**LEBANON PLANNING BOARD
MARCH 20, 2023 - 6:30 PM
COUNCIL CHAMBERS, CITY HALL OR
REMOTE VIA VIRTUAL PLATFORM
LEBANONNH.GOV/LIVE**

Staff Memorandum – PB2023-10-EXT

Re: Frito-Lay Product Exchange Center (PEC)
134 Airpark Rd.
Subject parcel 131-3-100
IND-L Zone
Site Plan Review Request

Sheet 3 (Existing Conditions and Demo Plan)

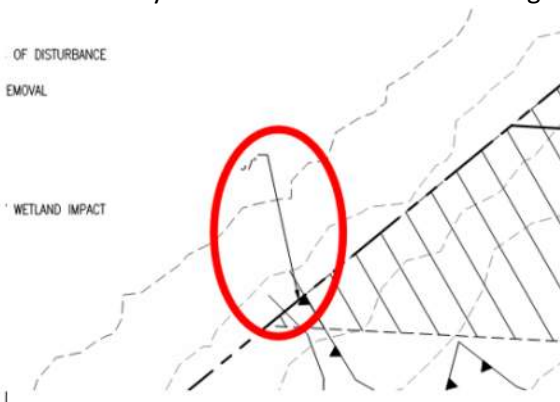
19. Add surveyor stamp or professional engineering stamp confirming compliance with Section 5.1.E.6 requiring existing topographic information prepared by a professional engineer registered in New Hampshire or land surveyor licensed in New Hampshire.

Surveyor's stamp will be added to the final plan
